Optimization of VIN Label for Panigale V4  
Models: Panigale V4 (all US and Canadian versions)  
Technical Service Bulletin SRV-TSB-18-012

Date: March 8<sup>th</sup>, 2018  
To: Dealer Principal, General Manager, Service Manager, North American Dealer Network  
From: Richard Kenton, Technical Director; Matthew Feinstein, Regulatory Compliance Manager

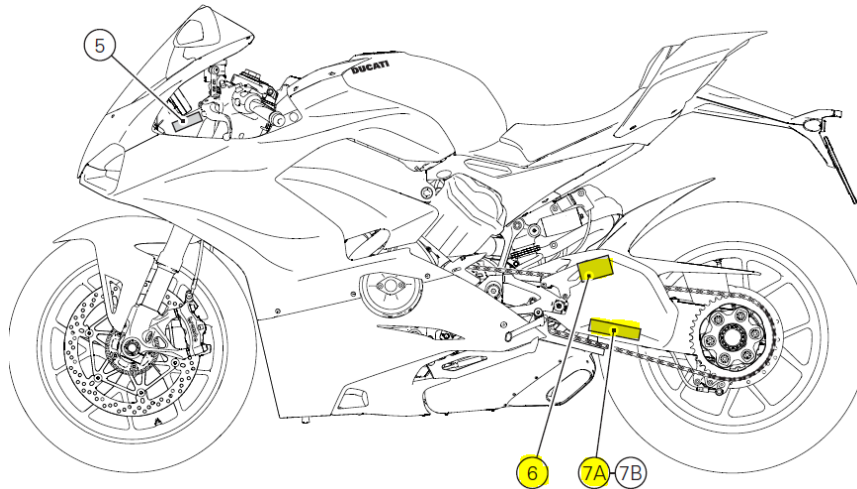
- 1) Locate the existing VIN labels, 6 and 7A, on the swinging arm of the motorcycle.

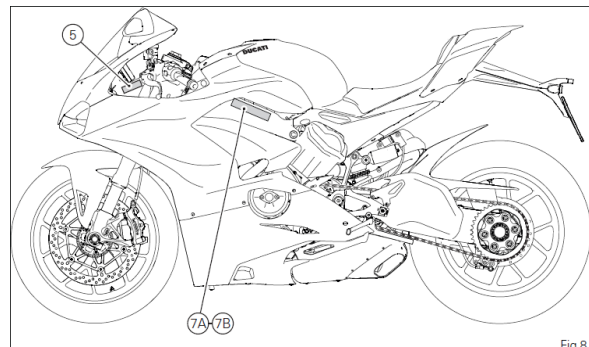
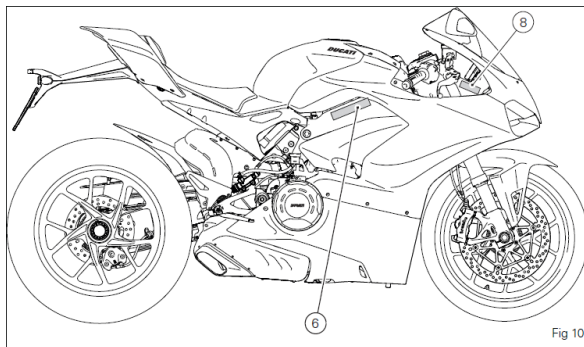
- 2) Carefully remove the existing 'Tamper Resistant' double-layer VIN labels. It is possible that they will be destroyed in the removal process and will leave behind residue that requires cleaning of the swinging arm. Ensure that the old VIN labels and all evidence of their former location is completely removed.
- 3) Clean the visible surface of the main (front) frame on both the left and right side of the motorcycle using warm soapy water, to ensure good adhesion of the new VIN labels. Rinse thoroughly and verify that the area is completely dry before proceeding. (See images below for clarity on the area to be cleaned)
- 4) Install the new VIN Labels as shown in the following images:
  - a. Label '6' gets relocated to the right side of the motorcycle:
